Riverside Center

Critique of Proposed Extell Development

Community Board 7, Mel Wymore, Chair

Riverside Working Group, Ethel Sheffer, Chair

59th Street is Marginalized

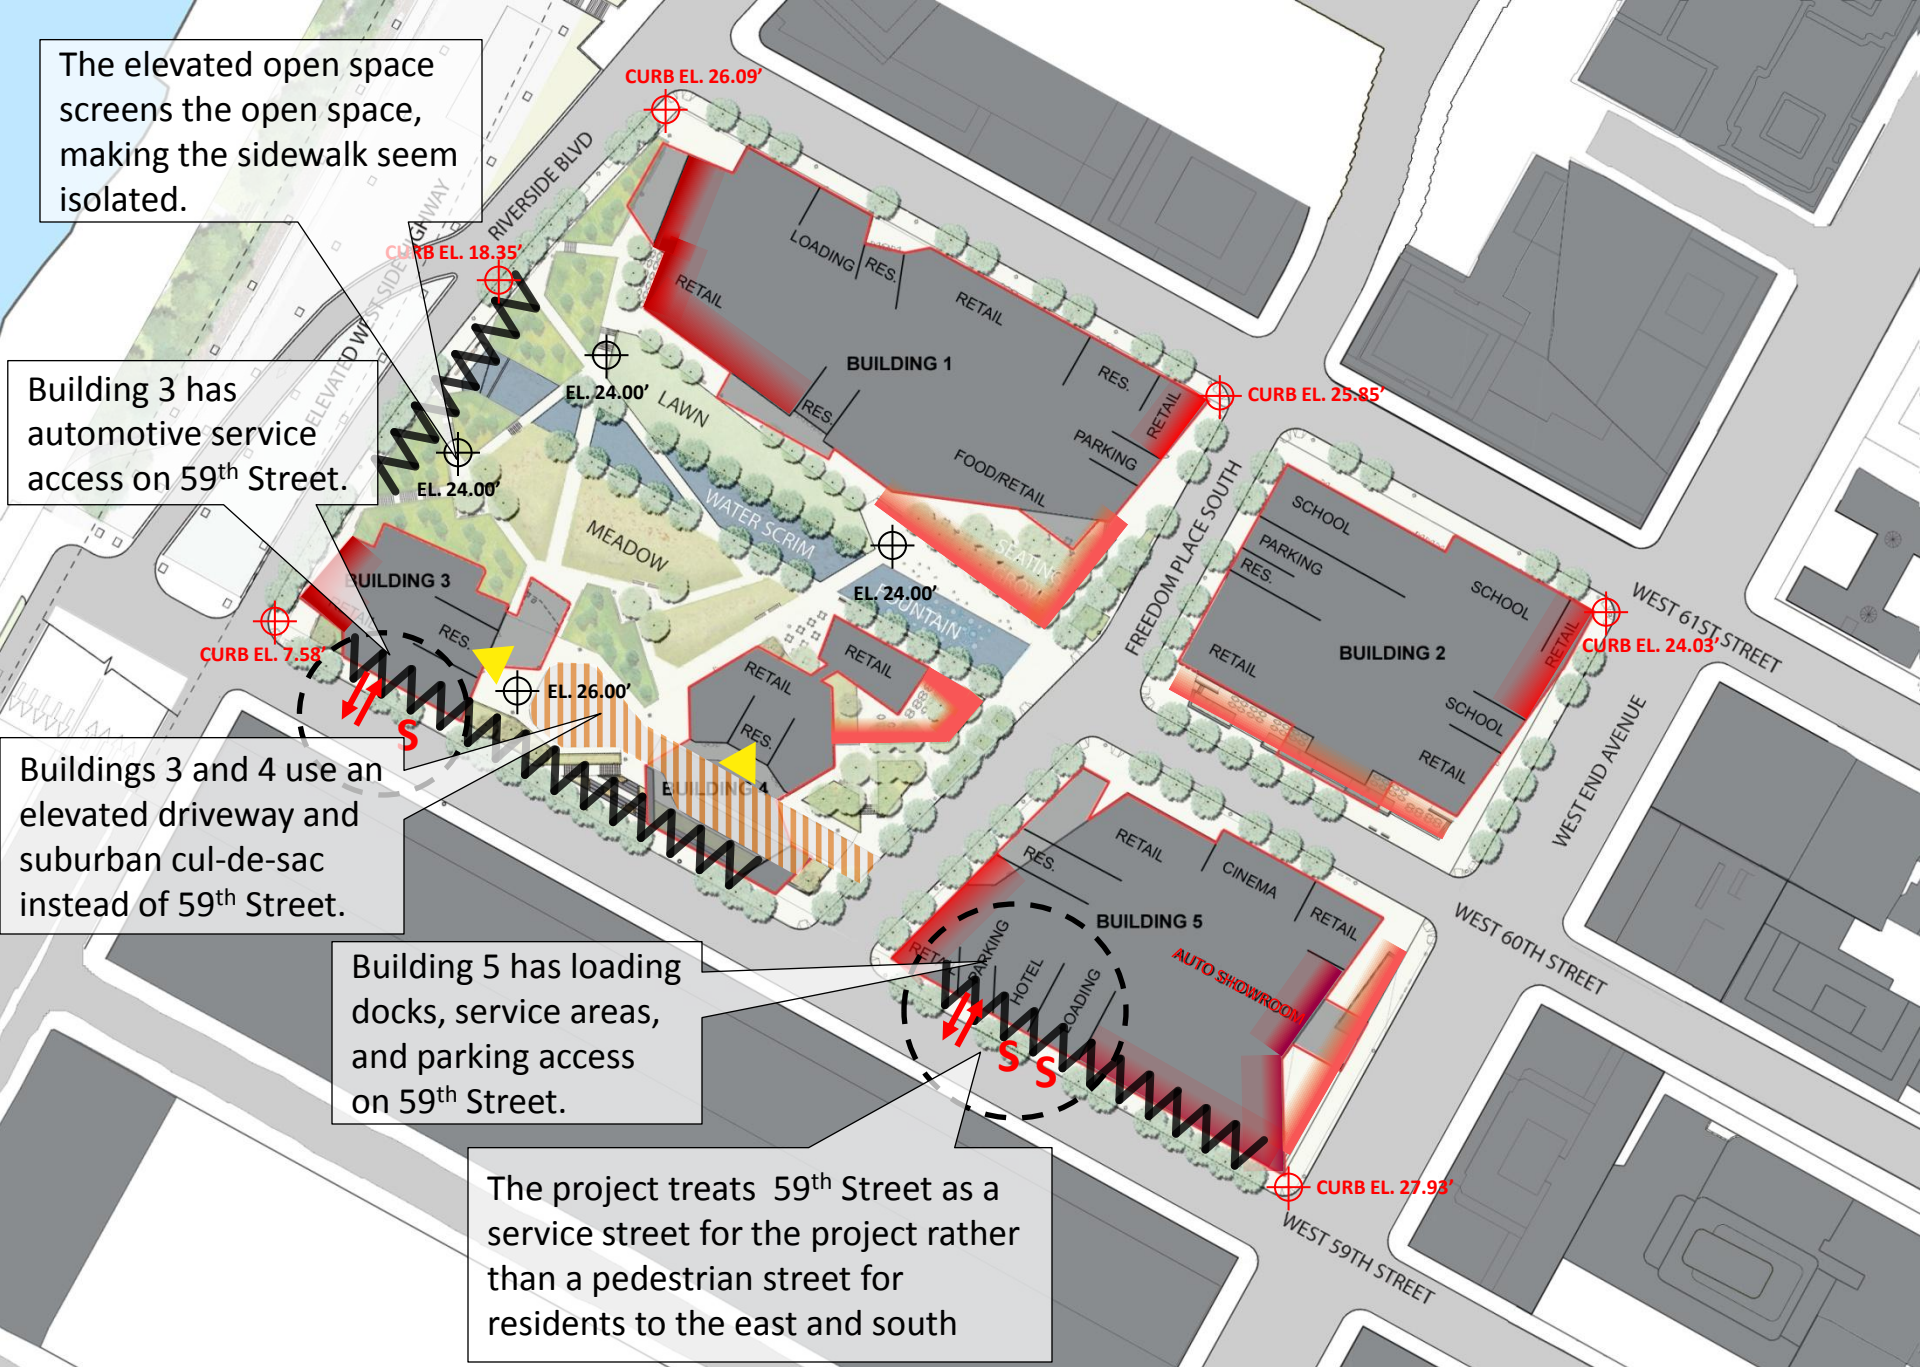
The project treats 59th Street as a service street for the project rather than a pedestrian street for residents to the east and south

Building 3 has automotive service access on 59th Street.

Buildings 3 and 4 use an elevated driveway and suburban cul-de-sac instead of 59th Street.

Building 5 has loading docks, service areas, and parking access on 59th Street.

The elevated open space screens the open space, making the sidewalk seem isolated.
